DATE: January 30, 2017
TO: Sarah Clark, Stanton Architecture - Applicant
FROM: Mark Luellen, Planning Department
RE: PPA Case No. 2016-014360PPA for 433 Mason Street

Preliminary Project Assessment

Date: January 30, 2017
Case No.: **2016-014360PPA**
Project Address: 433 Mason Street
Block/Lot: 0306/003
Zoning: C-3-G (Downtown – General)
80-130-F Height and Bulk District
Area Plan: Downtown
Project Sponsor: Sarah Clark
Stanton Architecture
1501 Mariposa Street, Suite 328
San Francisco, CA 94107
(415) 865-9600
Staff Contact: Carly Grob – (415) 575-9138
carly.grob@sfgov.org

Building Heights in the Vicinity of 433 Mason

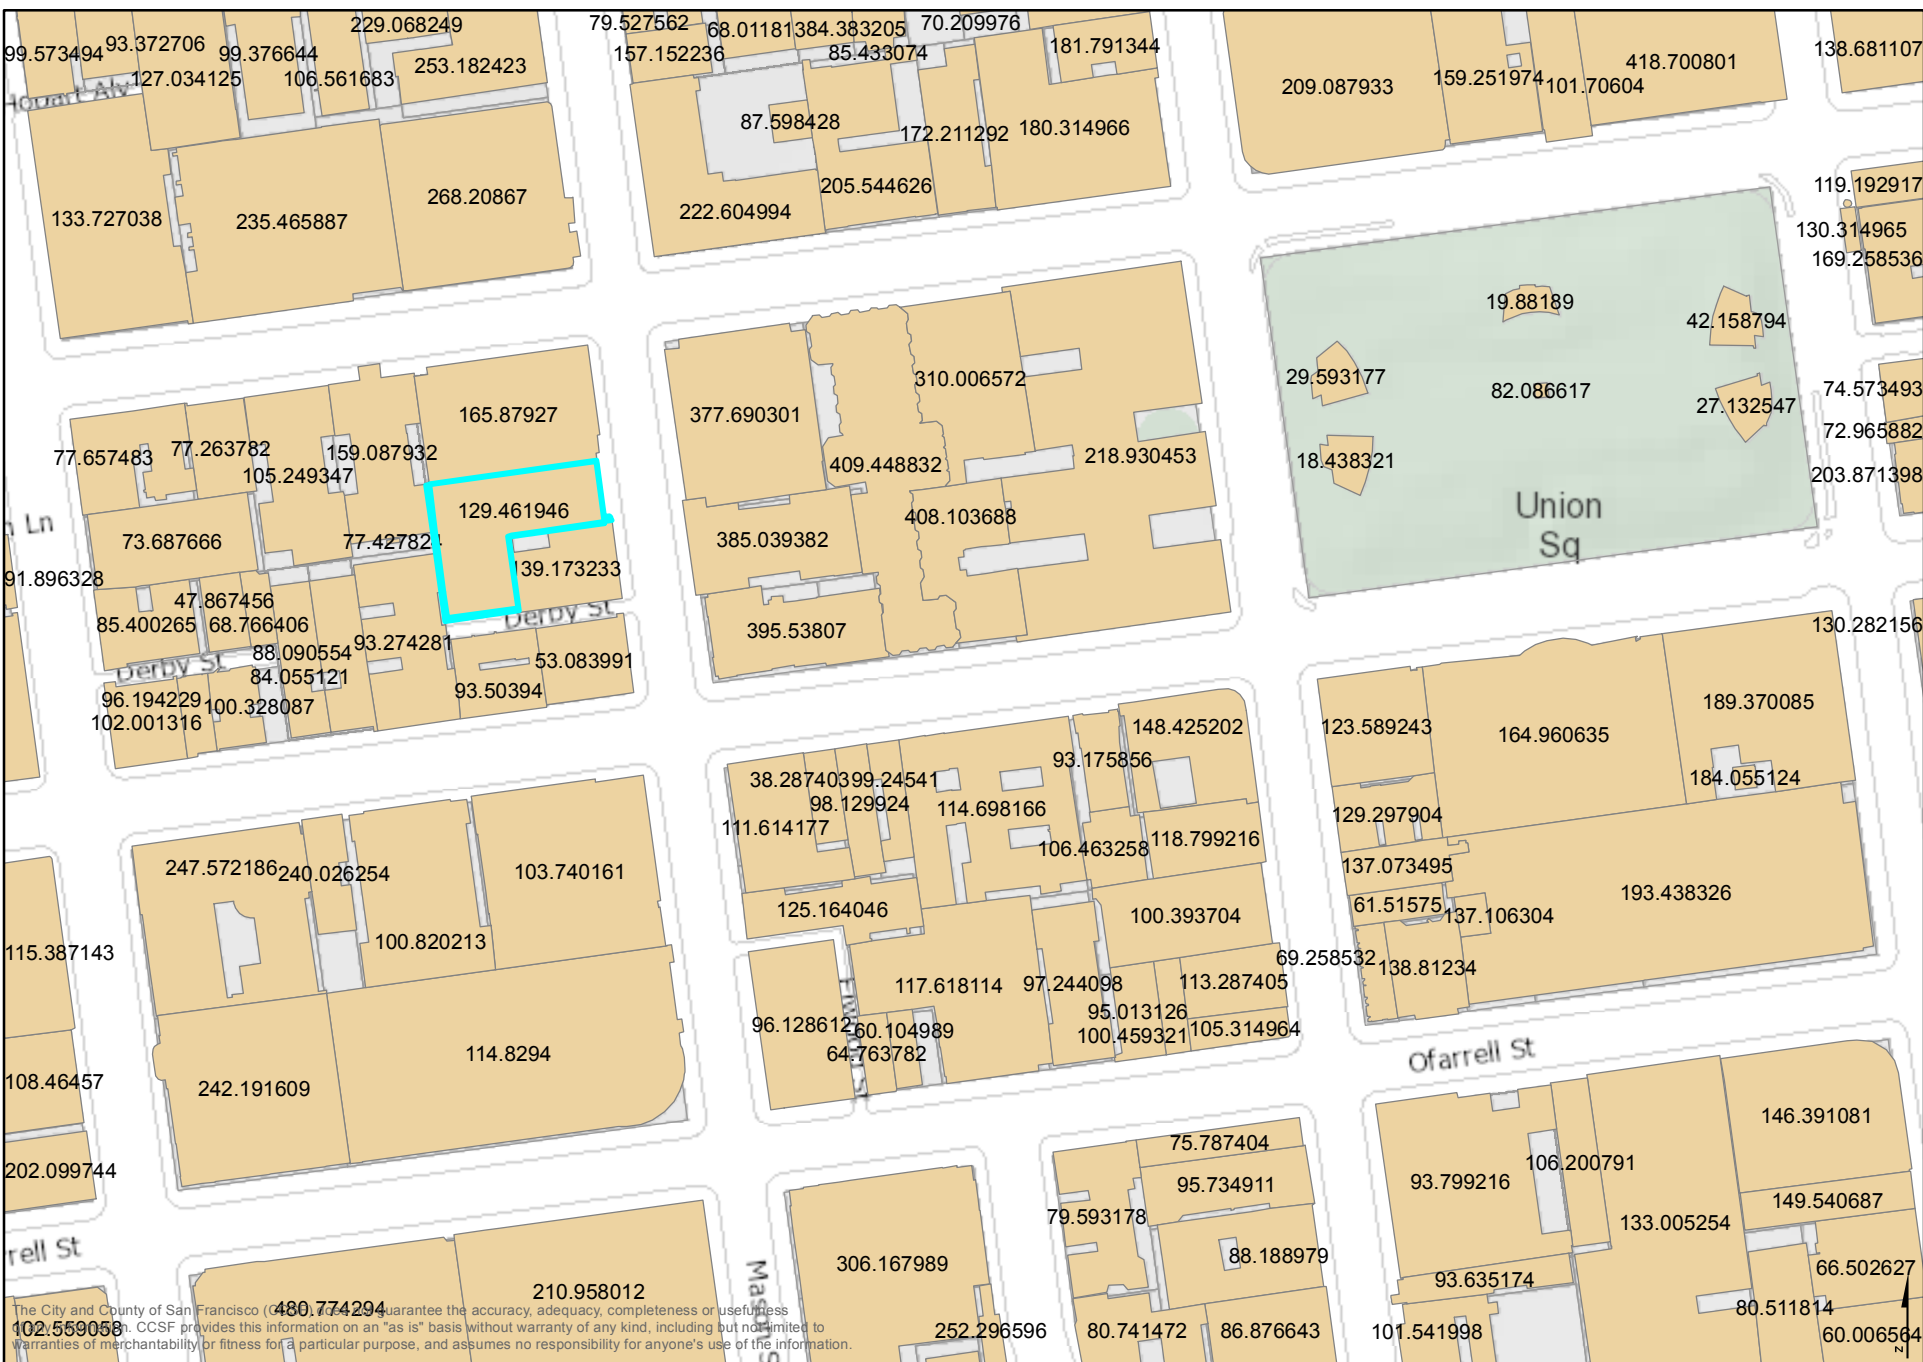
- The market demand for a hotel or motel of the type proposed.
2. **Height.** In the 80-130-F Zoning District, exceptions to the 80 foot height limit up to 130 feet may be approved in accordance with the provisions of Planning Code Section 309. In order to exceed 80 feet in height, you must seek an exception by filing a Downtown Project Authorization Application. Such height exemptions may be permitted provided that:

- The height of the building or structure does not exceed 130 feet; and
 - The additional height will not add significant shadows on public sidewalks and parks; and

- The structure provides an appropriate transition to adjacent higher or lower buildings; and
 - The additional height of the structure is set back an appropriate distance from the street frontage to maintain continuity of the predominant streetwall on the block.
